# TECHNICAL BULLETIN

**MODEL/DERIVATIVE:**  
Discovery Series II

**Bulletin N°:** 0031  
**CDS. ref:** L8638bu  
**Issue:** 1  
**Date:** 21.02.01

**PROBLEM:**  
**ENGINE HARNESS - FITTING PROCEDURE CARE POINTS**

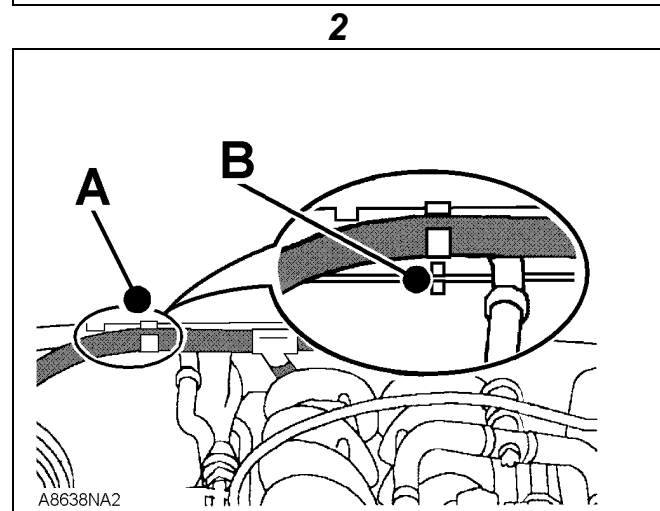
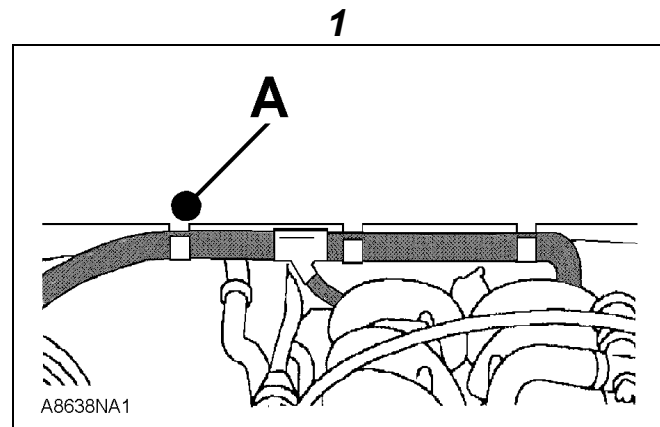
1. Partially remove the bonnet seal from the rear edge of the bonnet aperture to access the three harness clips.
2. Refer to illustration 1. If the clips are located as shown, clip 'A' must be repositioned as shown in illustration 2.
3. Refer to illustration 2. Move clip 'A' from its location in the notch to a new location directly above the brake pipe clip 'B'.

**NOTE:** There is no notch at the new location, push the clip fully onto the bulkhead flange where shown.

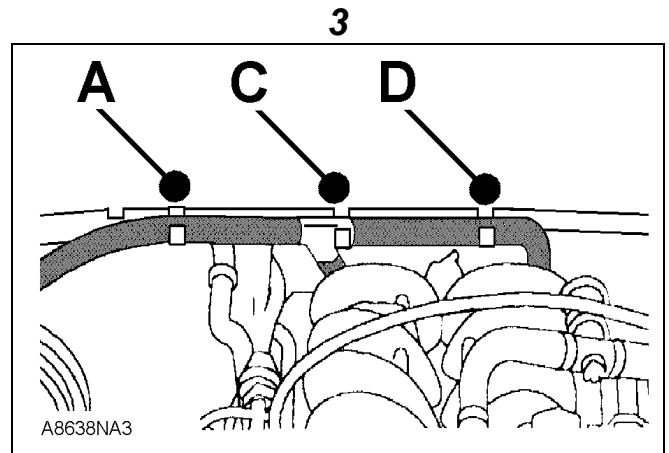
5. Referring to illustration 3, position the harness so that the 'Y' shaped plastic protector is placed into the centre clip 'C', then install the harness into clips 'A' and 'D'.

It is essential that the harness is routed to avoid slack or drooping between clips. Any excess harness should be located on the left hand side of the vehicle beyond the left hand clip 'D' and pushed back toward the bulkhead.
